# Technical Bulletin

## New Generation POPIT reversed wiring

► **D9127-CHI**

August 22, 2024

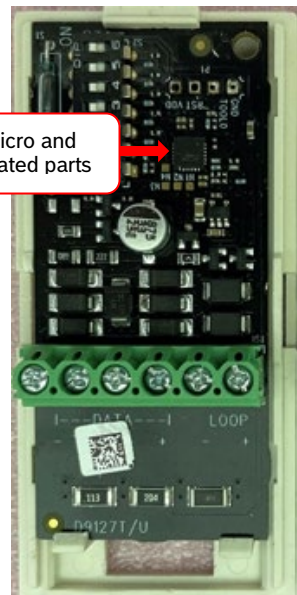
The new generation of POPIT modules will send an “Open” status when the bus wiring is reversed. Previous versions of the POPIT module would report “missing” if the bus wiring was reversed.

Bosch will update the new POPIT in the near future to provide the same indication of “missing” for reversed wiring in order to eliminate any potential confusion.
